# CITY OF ALBUQUERQUE

**RE: Explora STEM Expansion  
1701 Mountain NW  
Grading Plan Stamp Date: 11/22/19  
Drainage Supplemental Stamp Date: 11/22/19  
Hydrology File: J13D070**

**RE: Explora STEM Expansion (J13D070)**  
**Response to Comments**

CG-101

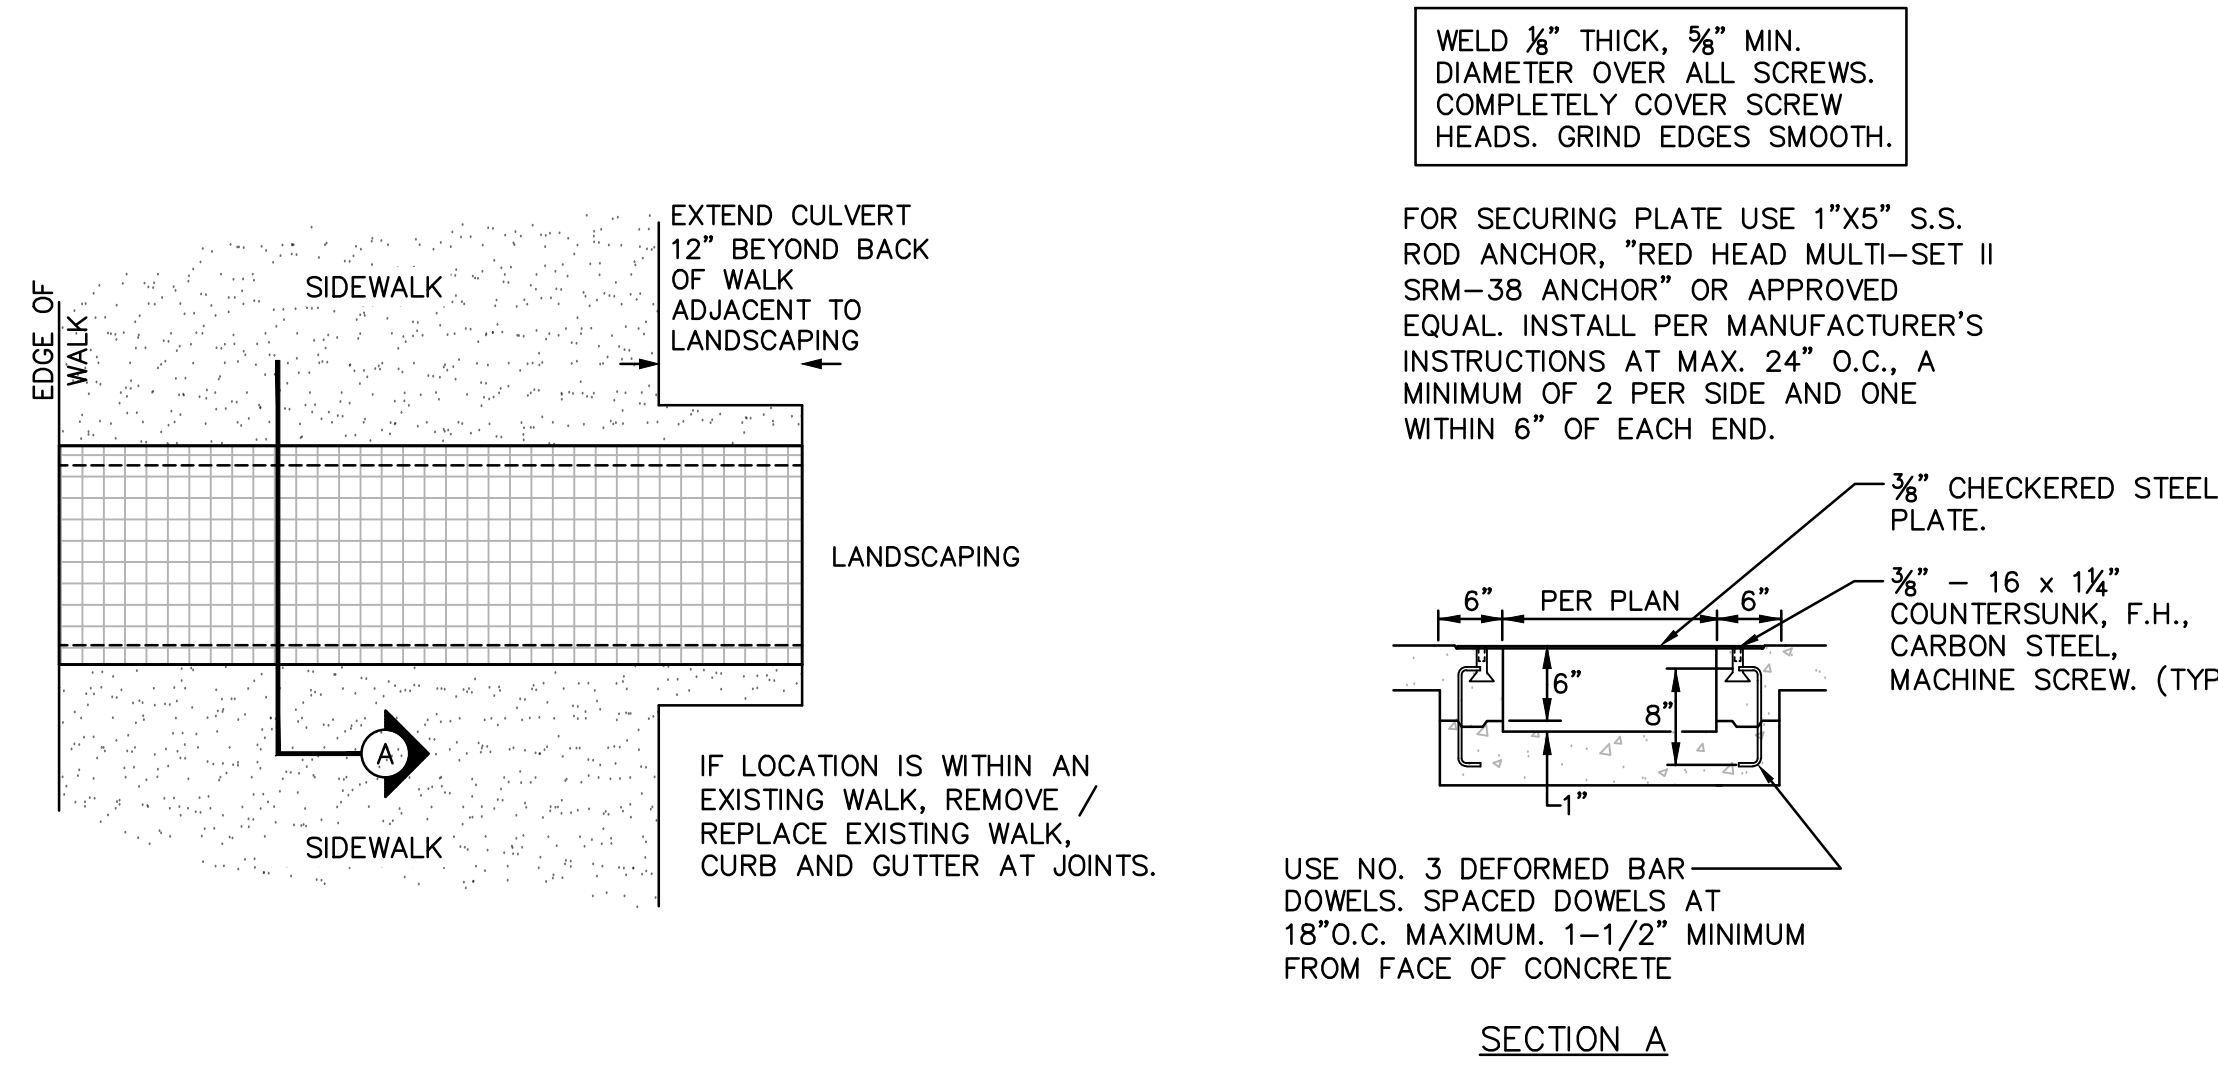
2. *An SO-19 Permit will be required and should be included on the request. Please include the standard SO-19 notes on the grading plan. Alternatively, you could use the sidewalk as a spillway; Sidewalk culverts are only required on collector and above roads.*

SO 19 Permit language and signature block was added to the plans.
